Product Change Notification

Type of Notification: Changing LED (LED501)

PLA15F-□, PLA30F-□, PLA50F-□, PLA100F-□, PLA150F-□, PLA300F-□, PLA600F-□

Fig.2.1 Photograph(PLA15F/30F/50F/100F) of "Existing" and "Changed"

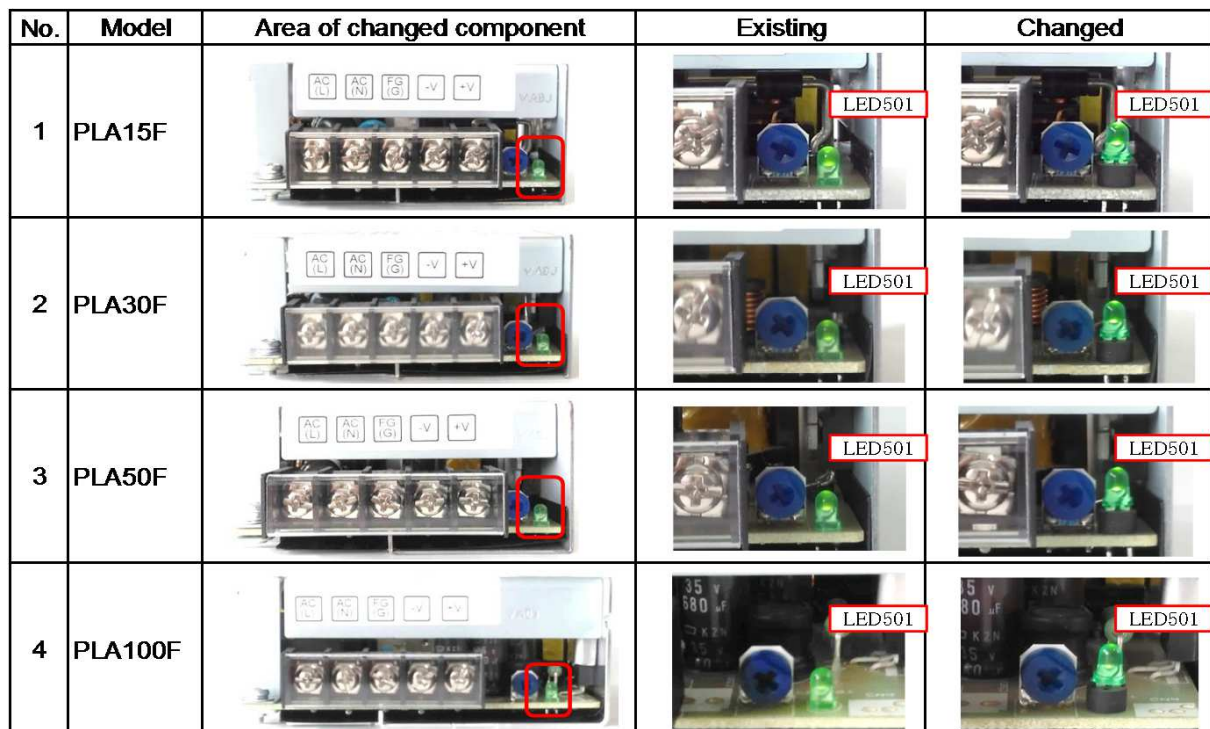
No.	Change parts	Contents	Existing	Changed	Note
1	LED (LED501)	Manufacturer	BRIGHTEK	STANLEY ELECTRIC	Spacer addition. LED height rises by around 3mm.
		Type name	1L0341G11A0DA	MPG3338S	
		Luminescent color	Green	Green	
		Form	Vertical	Vertical
